HIGHWAY WORK PROPOSAL

<u>COUNTY</u>	<u>STATE PROJECT</u>	<u>FEDERAL</u>	<u>PROJECT DESCRIPTION</u>	<u>HIGHWAY</u>
Waushara	6866-06-70	N/A	Wautoma - Mt Morris; North Townline Road To Cth G	STH 152

Addendum No. 02
ID 6866-06-70
Revised Sheet 4
June 28, 2023

FINISHED TYPICAL SECTIONS CULVERT REPLACEMENTS

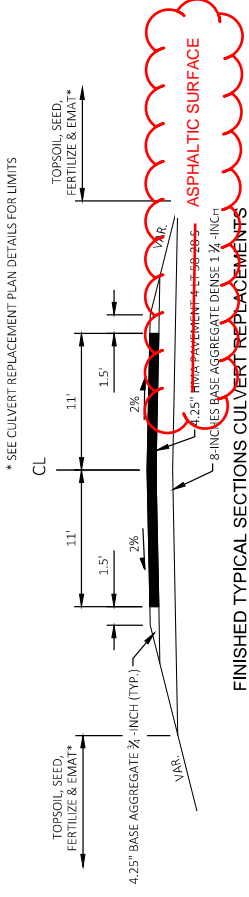
Revised Plan Sheets	
Plan Sheet	Plan Sheet Title (brief description of changes to sheet)
4	Typical Sections – Finished Typical Section Culvert Replacement changed to show Asphaltic Surface instead of HMA Pavement.
24	Miscellaneous Quantities – HMA Pavement Table modified due to quantity changes and the PWL Mix Use Table changed due to quantity changes.

ASPHALTIC SURFACE
